Long  
Island  
Power  
Authority

LSNRC-2045

Additional Information and Clarification  
as Requested by Staff Regarding the  
Decommissioning Project Termination Survey Plan  
Shoreham Nuclear Power Station - Unit 1  
Docket No. 50-322

# DATA EVALUATION - UNAFFECTED AREAS

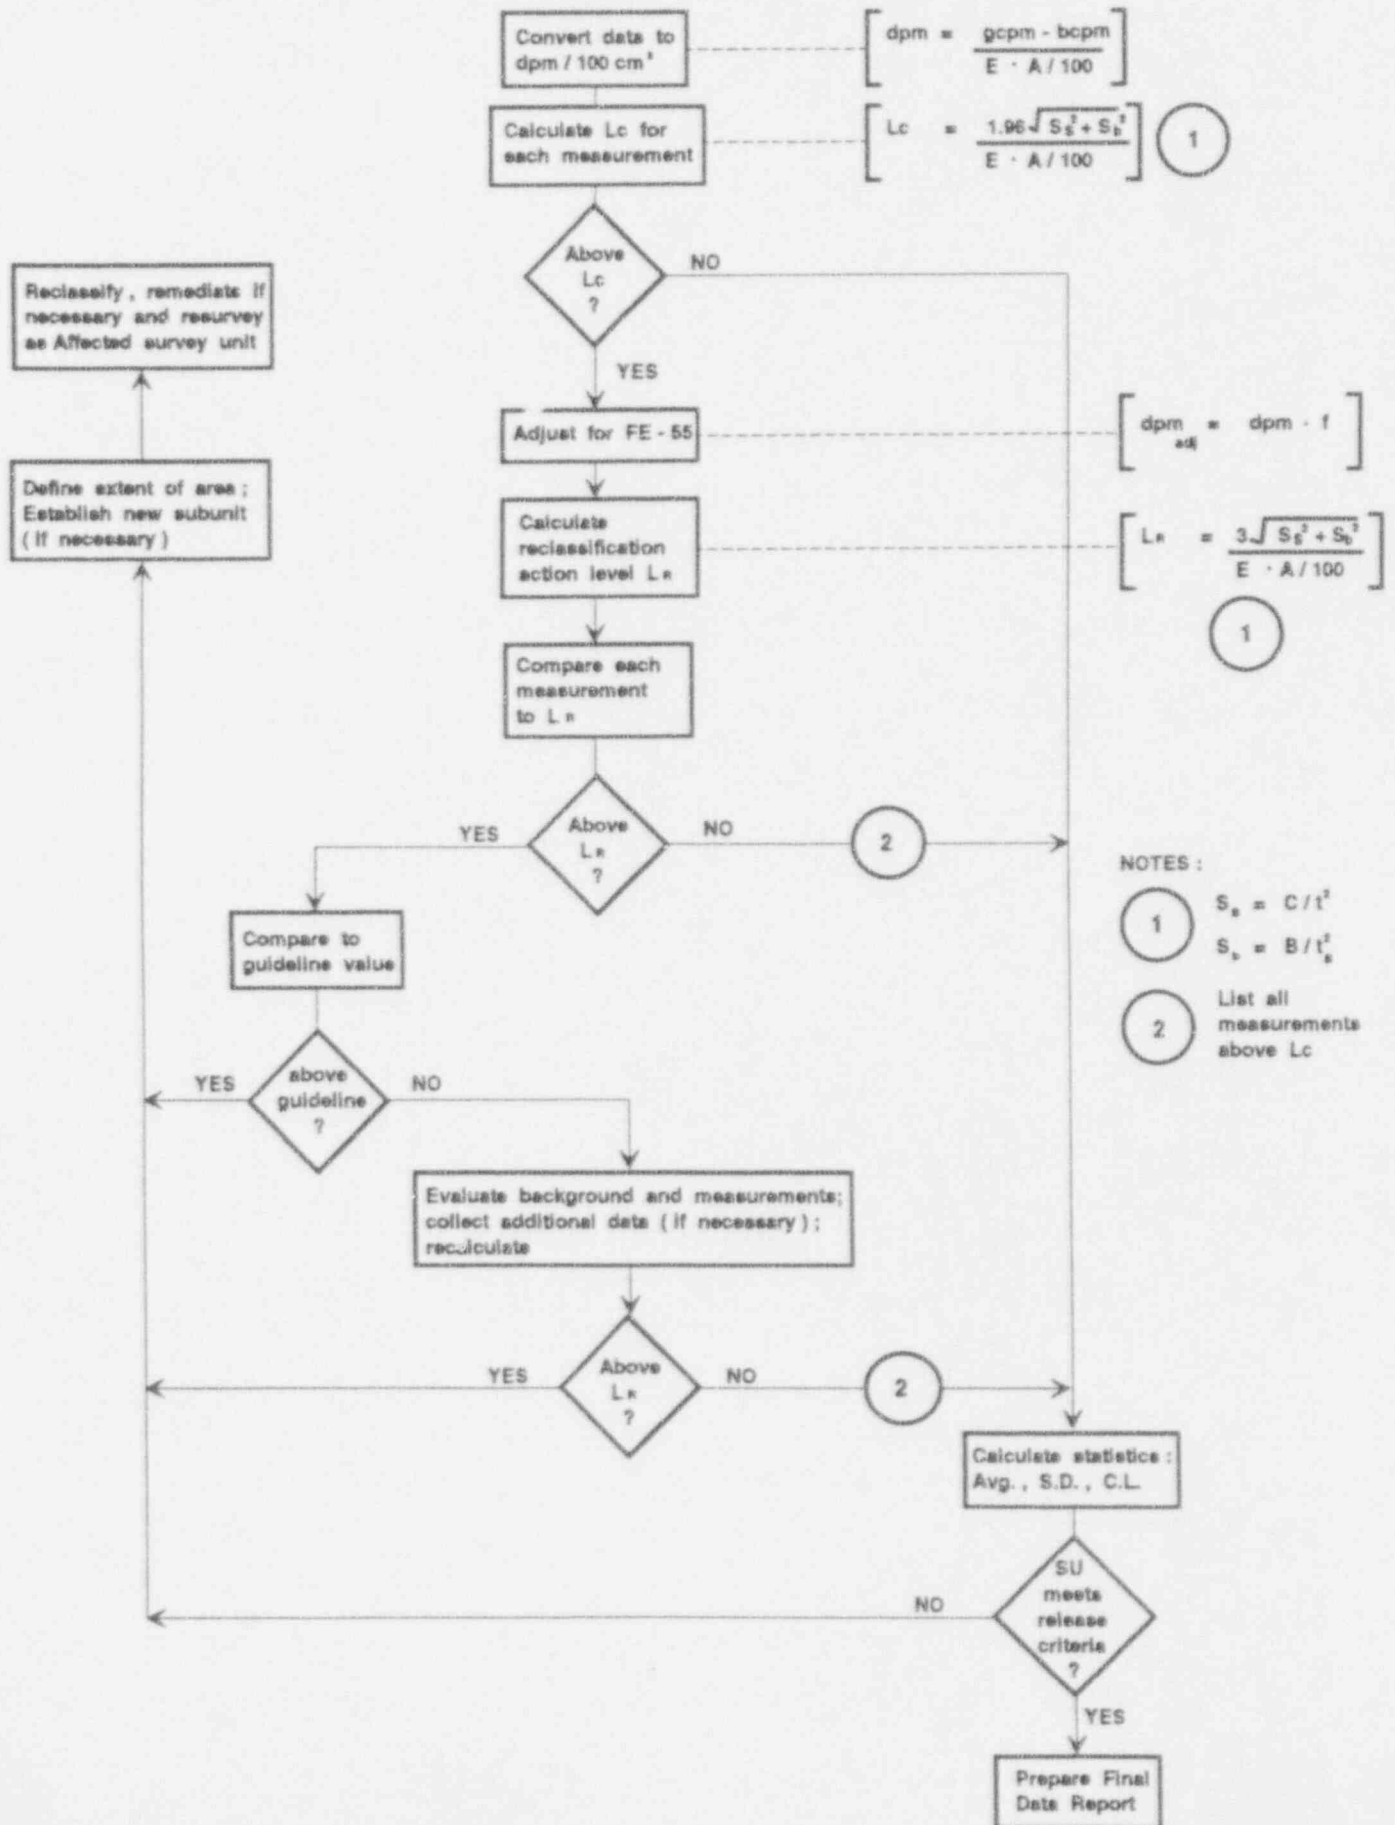
**NRC Comment:** The NRC Staff does not agree with the LIPA proposal to use 50 % of the 5,000 dpm/100 cm<sup>2</sup> guideline value for direct beta-gamma surface contamination measurements as the action level for investigation (and potential reclassification) in unaffected areas. An action level has been suggested which is similar to the critical level concept, but at a higher probability level, perhaps three or four sigma. Please provide a definition of the proposed action level and explain how it will be implemented.

**LIPA Response:** LIPA will calculate an action level,  $L_R$ , for direct beta-gama measurements and use it to screen each measurement which has been flagged as being above background as described in response No. 4 above. This action level is defined as:

The attached flow chart summarizes the data evaluation process for unaffected survey units. It shows how the data are evaluated and screened against the critical level and the action level. It identifies the actions taken when measurements exceed the action level, including reclassification and resurvey if required. It should be noted that LIPA has previously agreed to the use of an action level of 25% of the guideline values for all other measurements of surface contamination, i.e., removable beta-gama, removable alpha and direct alpha, and intend to retain this aspect of the survey program.

# DATA EVALUATION - AFFECTED AREAS

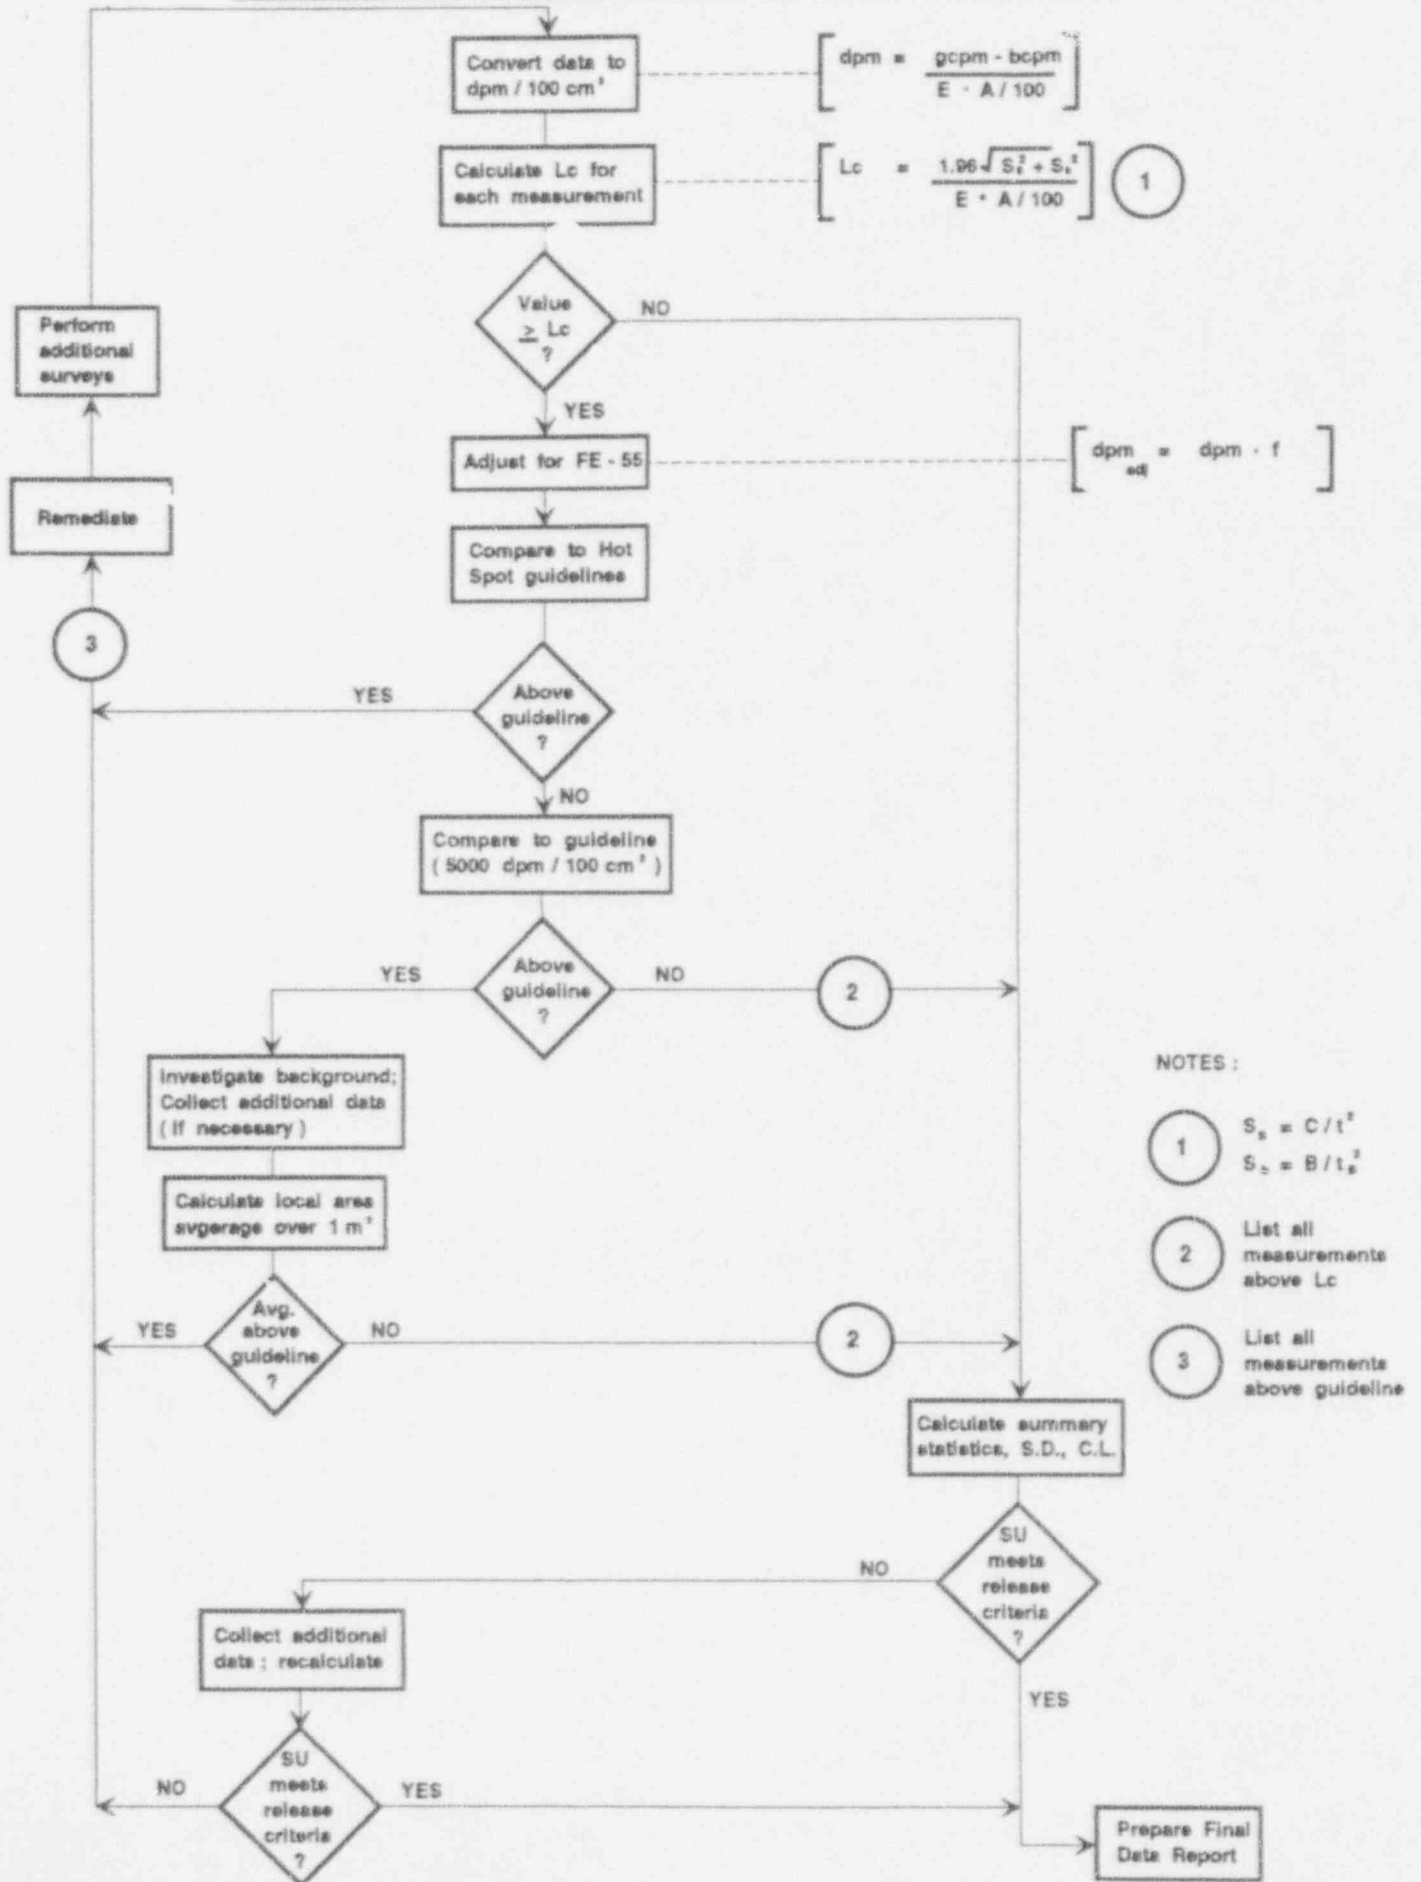
**NRC Comment:** Please identify in the Release Record data report for each survey unit, all instances where individual surface contamination measurements are above guideline values in affected areas. Summarize the investigation and show the evaluation to determine if the local area average exceeds the guideline value. For any cases where the guideline value is exceeded, describe the remediation and present the results of the resurvey which demonstrates that the release criteria have been met.

**LIPA Response:** LIPA will identify in the Release Record data report for each survey unit, all instances where individual surface contamination measurements are above guideline values in affected areas. The Release Record will summarize the investigation and the evaluation to determine if the local area averages exceed the guideline value. For any cases where the guideline value is exceeded, the remediation will be described. Results of the resurvey will be presented to demonstrate that the release criteria have been met. The attached flow chart summarizes the data evaluation process for affected areas. It shows the identification of all measurements above the critical level. It includes the screening of each measurement against the elevated level guideline and the average guideline values, and the response when measurements fail the test.
